Access Compliance Report

Public Rights-of-Way

(Curb Ramps)

Intersection ID: 12358	Main Street: HARRILL_ST	Cross Street: VAN_EVERY_ST	Location: E
ADA ID: 1CA24AC949E6	Ramp Type: PerpDiag	Initial Pass/Fail: Fail	Overall Compliance: No
Severity Score: 22.5			
Codes/Mitigation Info/Possible Solution		Field Measurements/Component Compliance

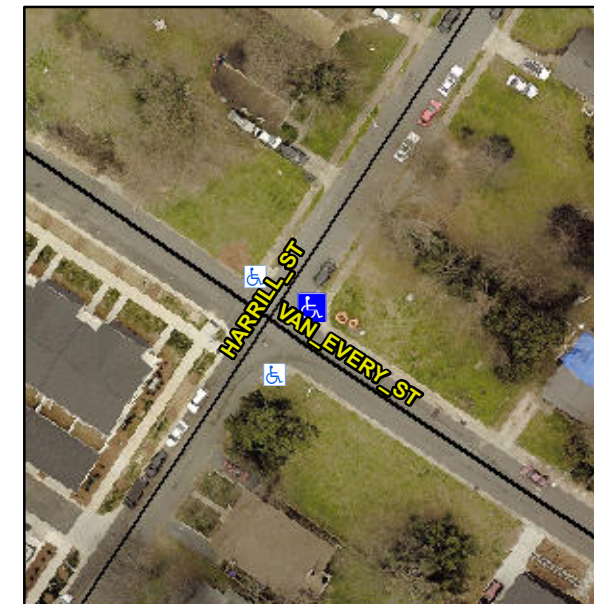
Not Found, R304.5.1, R304.2.2, R304.5.3

Compliance	Description	Data	Compliance	Description	Data
N/A	Ramp Length (in)	66.0	No	Ramp Slope (%)	8.5
No	Ramp Width (in)	36.0	No	Ramp XSlope (%)	2.6
N/A	Flare Type LT	N/A	N/A	Flare Type RT	N/A
N/A	Flare Slope LT (%)	N/A	N/A	Flare Slope RT (%)	N/A
N/A	Flare Traversable LT?	N/A	N/A	Flare Traversable RT?	N/A
N/A	Landing Length (in)	N/A	N/A	DWS Provided?	N/A
N/A	Landing Width (in)	N/A	N/A	DWS Contrast?	N/A
N/A	Landing Slope (%)	N/A	N/A	DWS Length (in)	N/A
N/A	Landing X Slope (%)	N/A	N/A	DWS Full Width?	N/A
N/A	Landing Curb? (Y/N)	N/A	N/A	DWS Offset (in)	N/A
N/A	Shared Landing?	N/A			
N/A	Gutter Ponding?	N/A	N/A	Gutter Slope (%)	N/A
N/A	Gutter Lip Ht (in)	N/A	N/A	Gutter X Slope (%)	N/A
N/A	Painted X Walk1?	No	N/A	Painted X Walk2?	No
	X Walk 1 Direction	To NW		X Walk 2 Direction	To SW
N/A	X Walk 1 Width (in)	N/A	N/A	X Walk 2 Width (in)	N/A
	X Walk 1 Slope (%)	3.4		X Walk 2 Slope (%)	0.6
	X Walk 1 X Slope (%)	2.3		X Walk 2 X Slope (%)	1.4

Remove & Replace Curb Ramp With Two New Directional Ramps or Equivalent.
